Minutes – Executive Policy Committee – September 21, 2011

Item No. 4 Development Agreement Amendment - 535 Ham Street (Transcona Ward) File DASZ 21/2009

Title: **Request to Amend Council Orders**
File DASZ 21/09 – 535 Ham Street

APPENDIX "A" – DASZ 21/09 Map

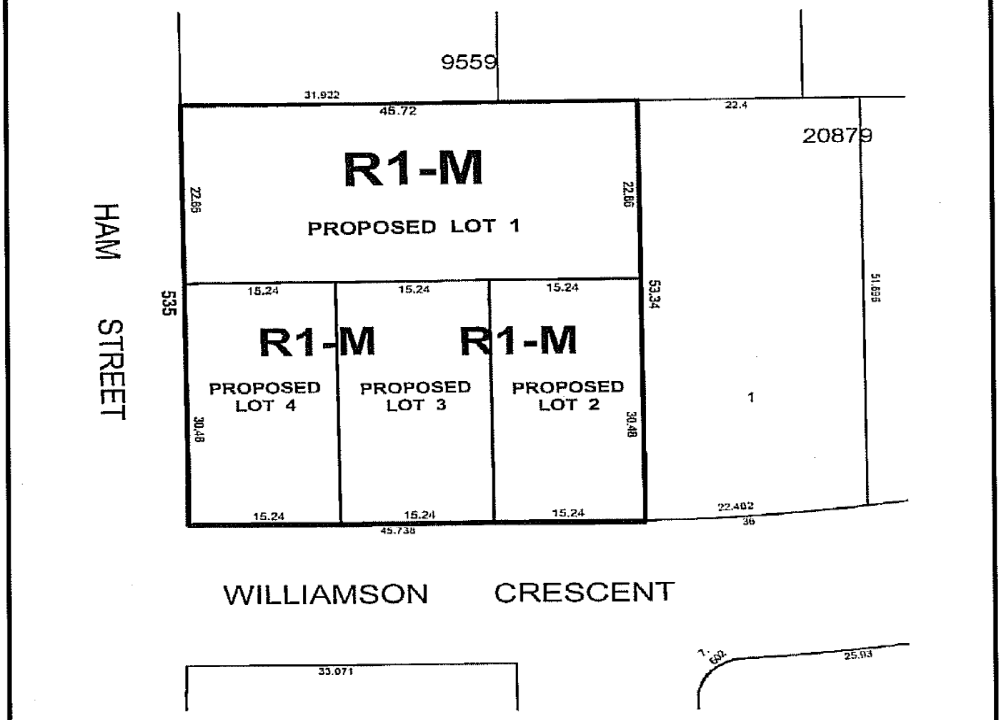
The applicant, Sytko Construction on behalf of the owner Mr. Lloyd Yang has requested that Clause 5 of the August 20, 2009 ACG report contained in Council's instructions be deleted on the basis that this requirement is unfitting to the subdivision, see attached correspondence dated June 15, 2011, Appendix "B".

In section 5 of the servicing agreement it lays out a list of city services that are to be installed on what is known as lot 1 in the subdivision plan. This lot has Ham St. frontage and would maintain that after the subdivision is finalized. The current state of this frontage (and that of the entire portion of Ham St., south of Grassie) is a gravel access road, land drainage into ditches. This lot also makes use of a holding tank and well-drawn water. This is what we would simply like to continue to make use of for lot 1.

Ham St., south of Grassie has seen limited use as a major access route to the abutting development, and the future plans as proposed by the City of Winnipeg include a termination at the intersection of Ham and Grassie in a cul-de-sac adjacent to 316 Grassie blvd. This will now limit the use of Ham as a point of entry altogether. The few homeowners on Ham will now have to travel through the current development to their homes. The far south end of Ham is already terminated in this fashion, with a simple gravel cul-de-sac in place. All previous development done points to Ham St. maintaining its current state, of the graded gravel road and ditch drainage.

1. That Clause 5 of the August 20, 2009 Administrative Coordinating Group report contained in Item 2 of the Report of the Standing Policy Committee on Property and Development adopted by Council on November 25, 2009, be deleted, namely:
